**ADDENDUM 5 (PENDING DSA APPROVAL)**

**PROJECT:** Santa Ana College  
Science Center

**DATE:** 10/4/2017

**DSA File No.:** 30-C2  
**DSA Applications No.:** 04-115788  
**HGA Commission No.:** 3584-001-00

3) REVISION TO  
THE AIR  
HANDLING UNIT  
COOLING COIL  
CAPACITY AND  
MONITORING OF  
ROOM RELATIVE  
HUMIDITY

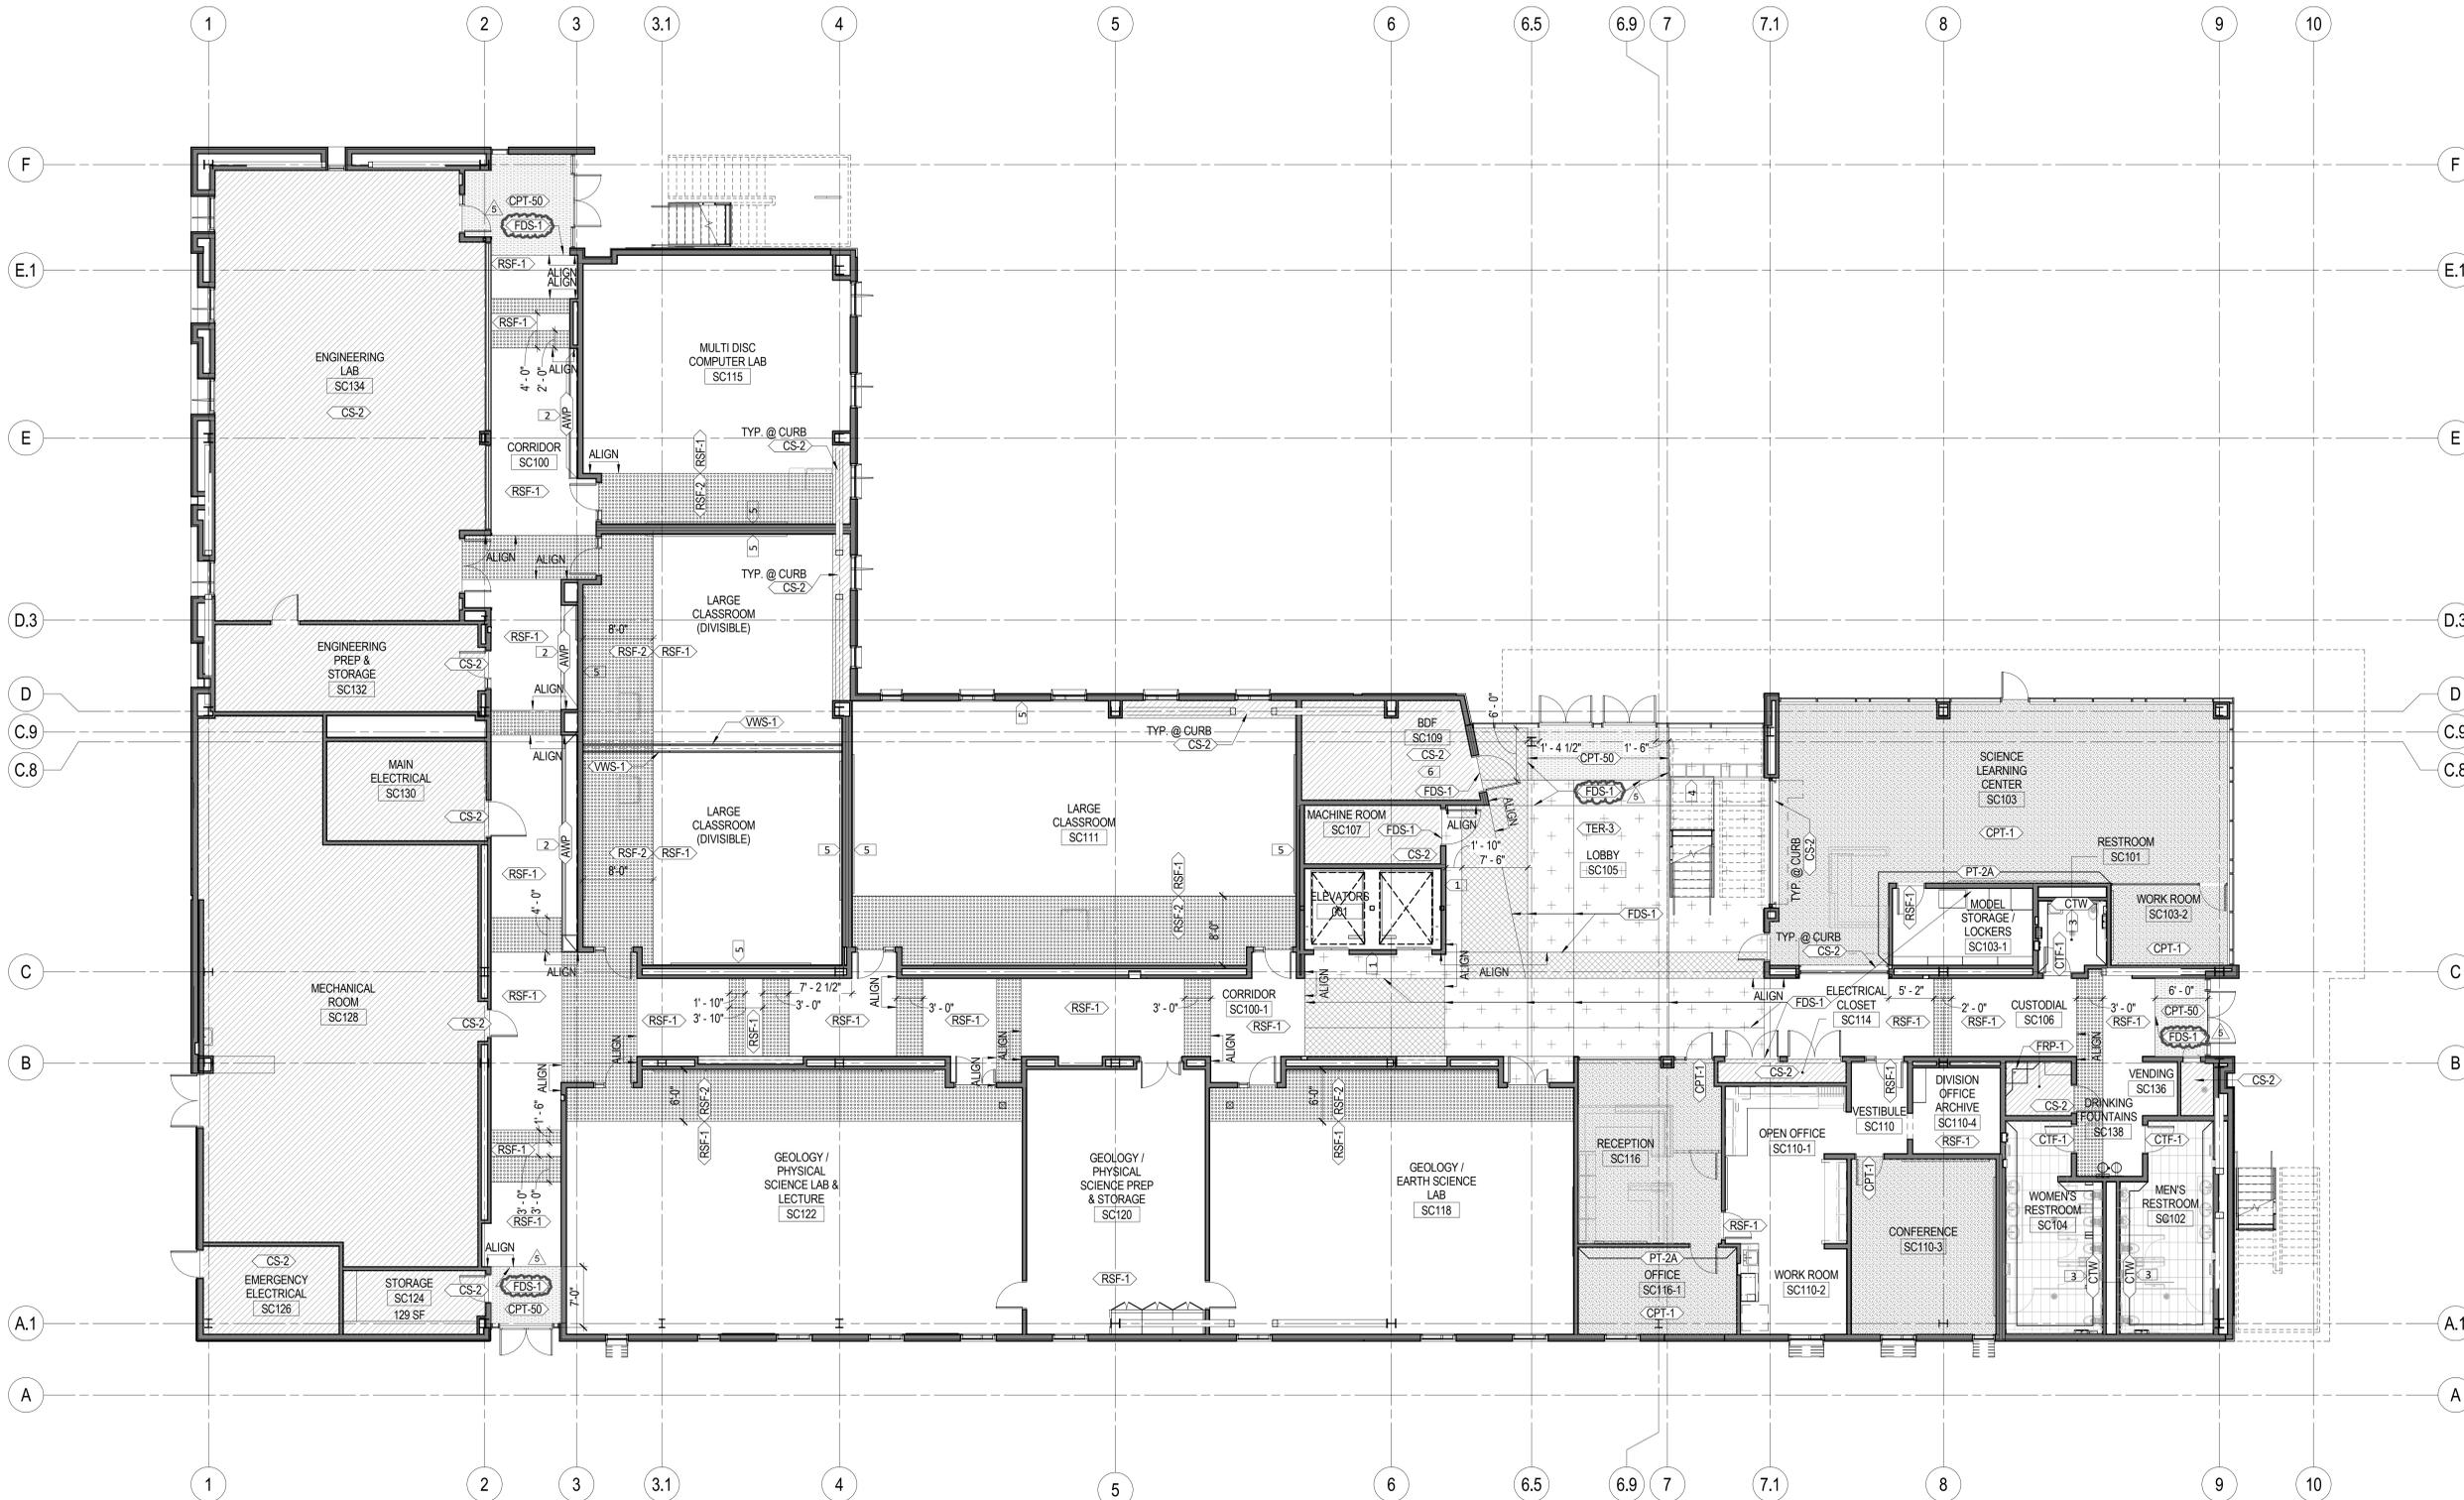
To provide cooling coil discharge air temperature at 51  
degrees at each of the three air handling units and  
provide relative humidity sensor option in the room  
thermostats. Monitor room relative humidity from the  
BMS to allow dehumidification sequence of the three  
air handling units. *ADD-3 ADD-5*

**FIRE ALARM NOTES AND DETAILS**

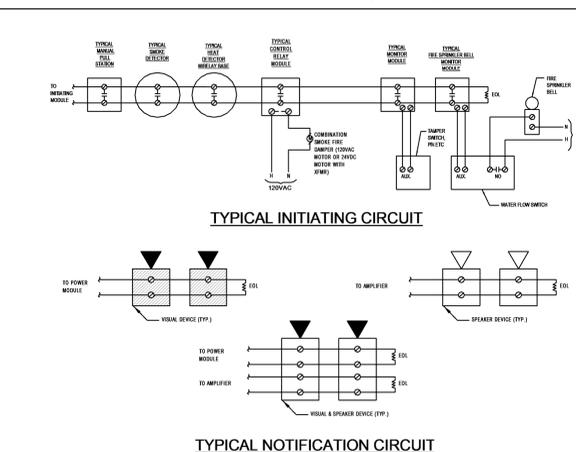
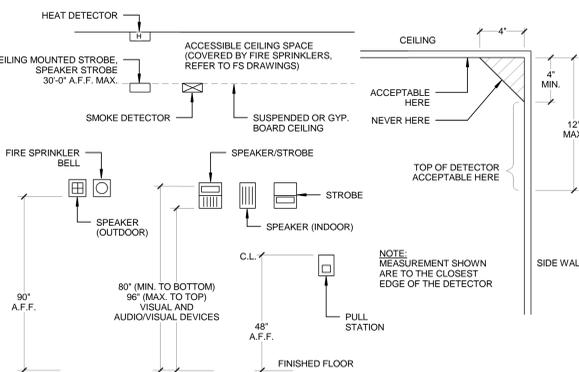
**Item AD-5-5: Revise EF4.0**

- FIRE ALARM NOTES AND DETAILS, revise as indicated.

**FIRE ALARM RISER DIAGRAM**

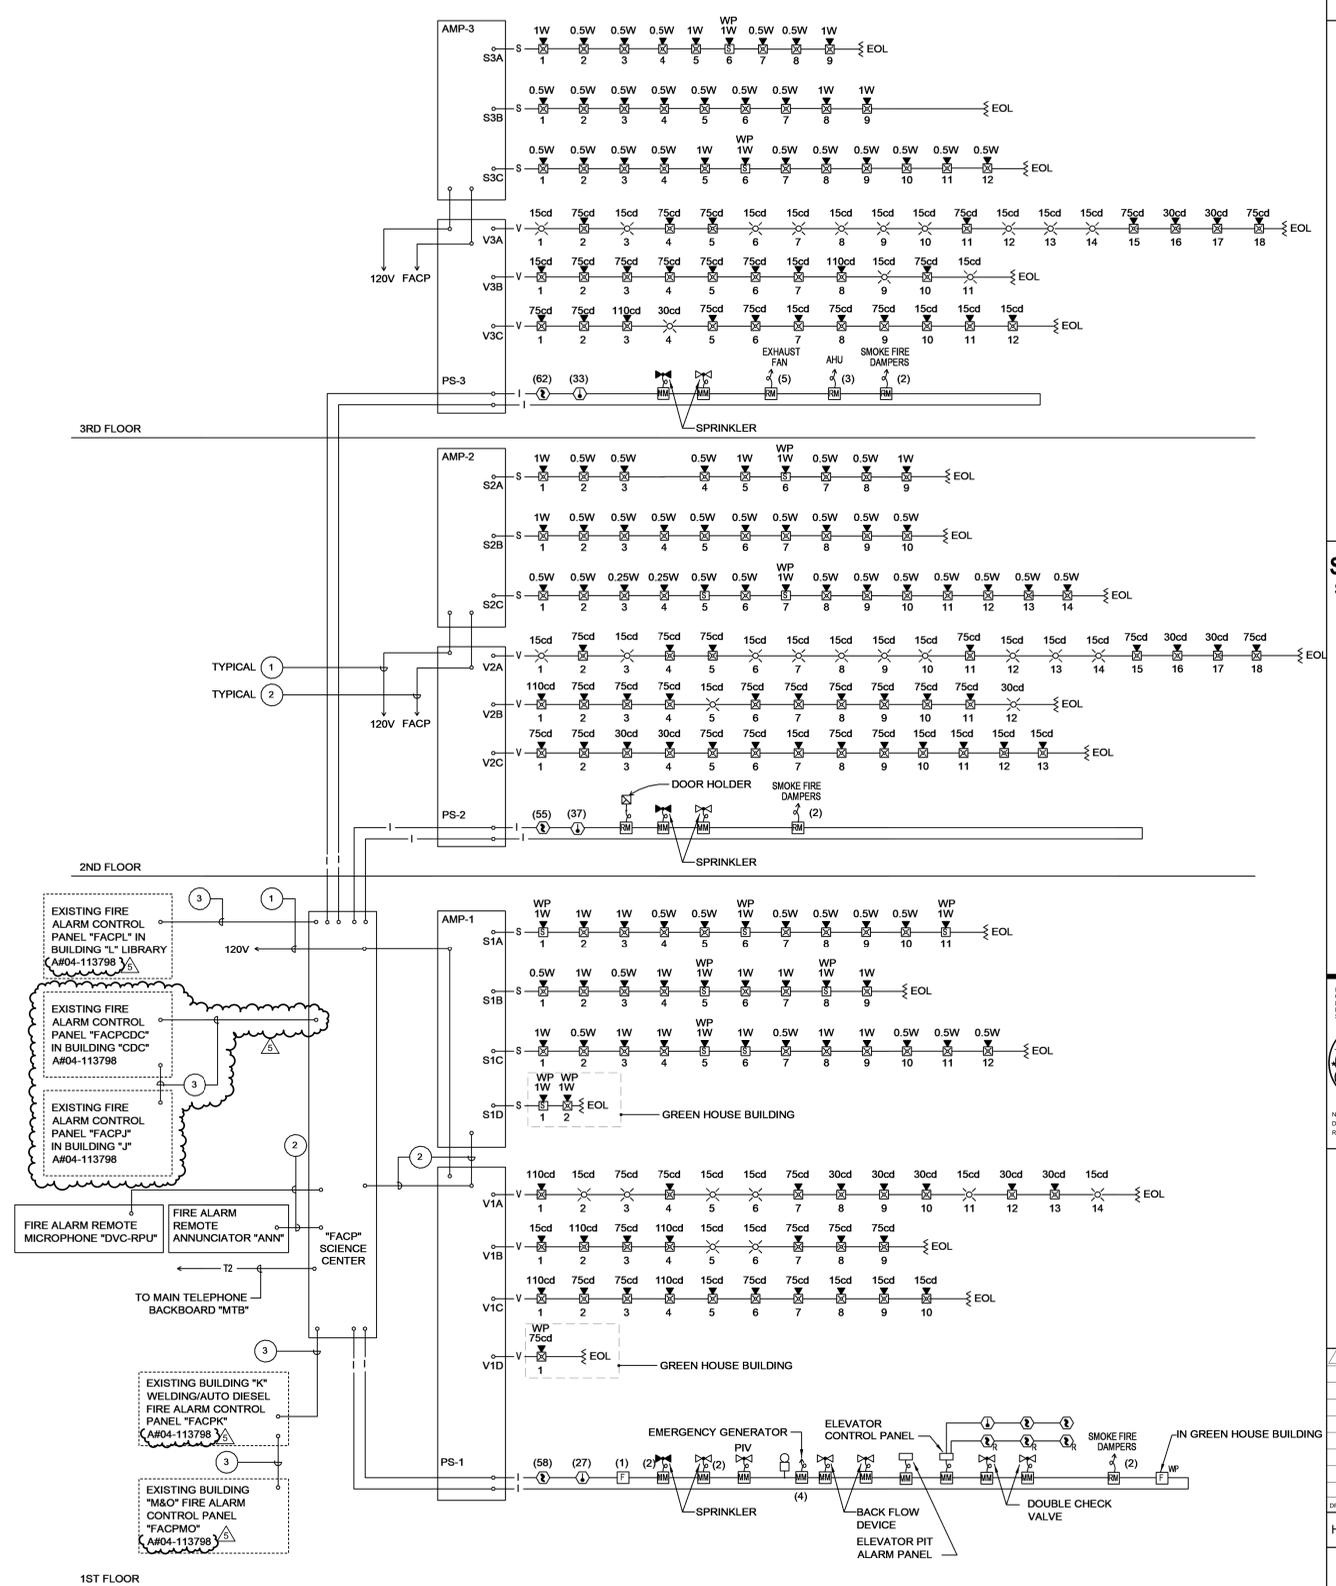
**Item AD-5-6: Revise EF4.1**

- FIRE ALARM RISER DIAGRAM, revise as indicated.

1 OVERALL SITE FIRE ALARM PLAN  
1" = 60'-0"

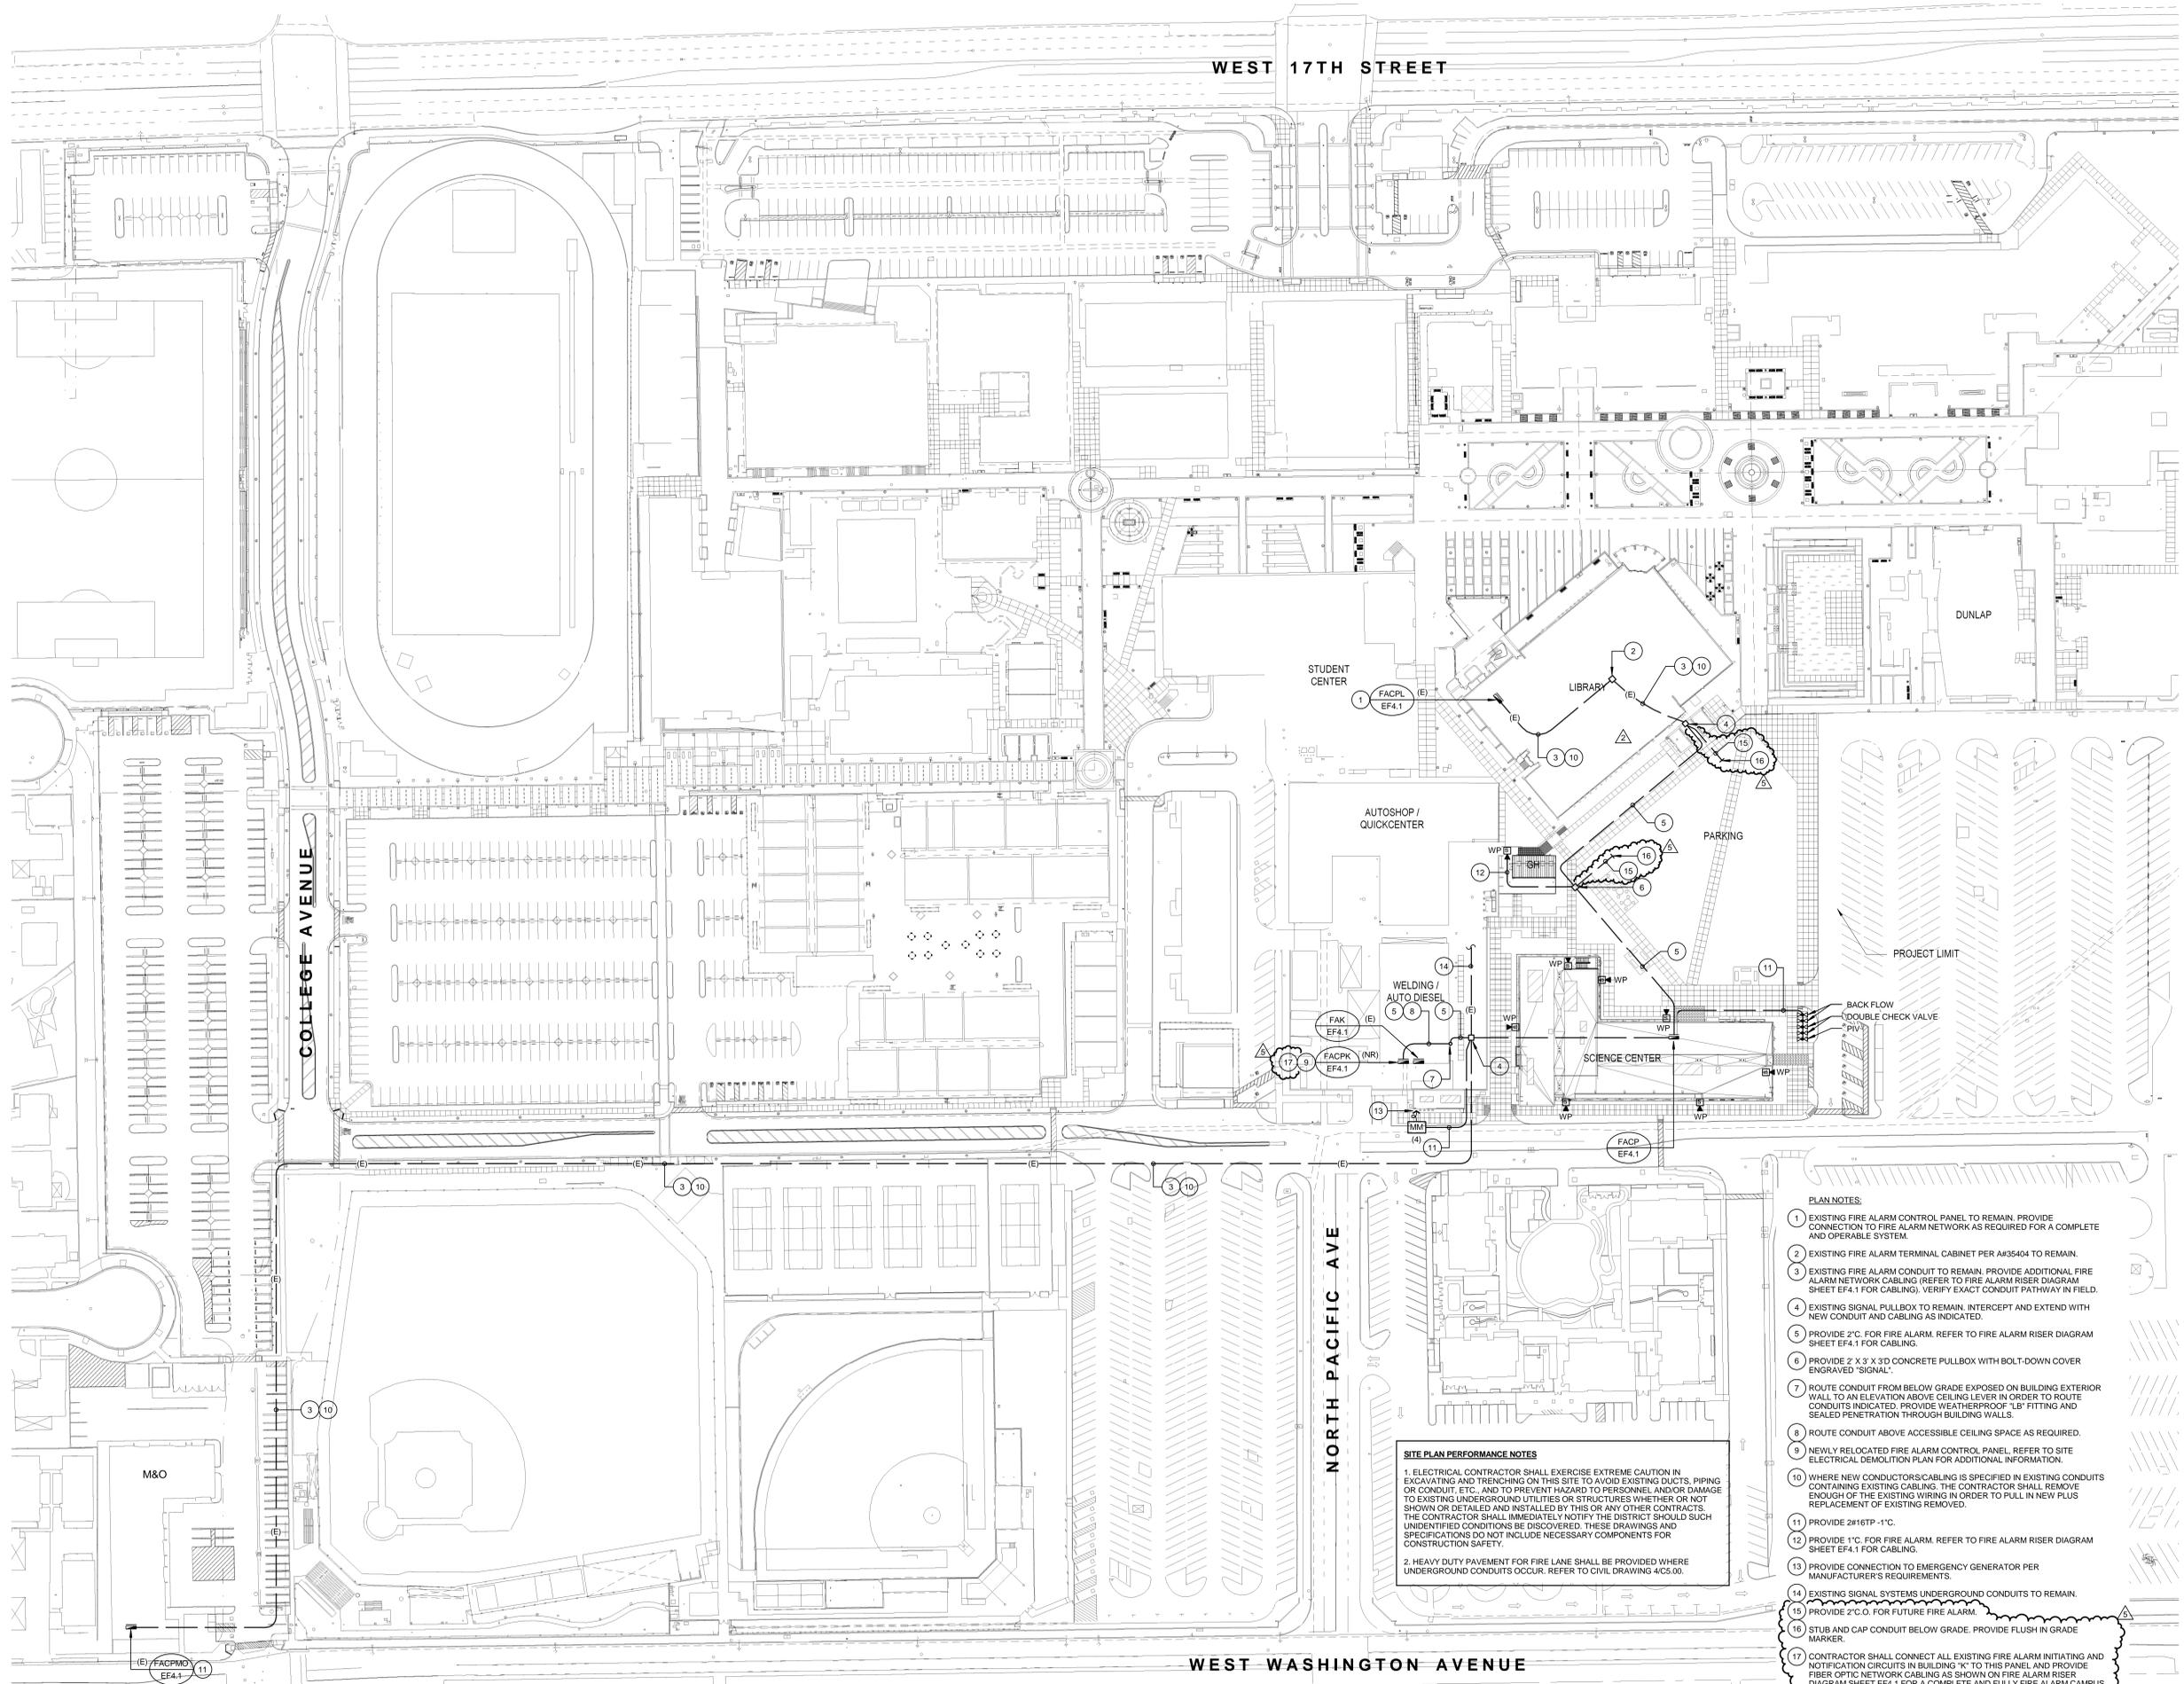
**Item AD-5-7: Revise EF4.5**

- OVERALL SITE FIRE ALARM PLAN, revise as indicated.
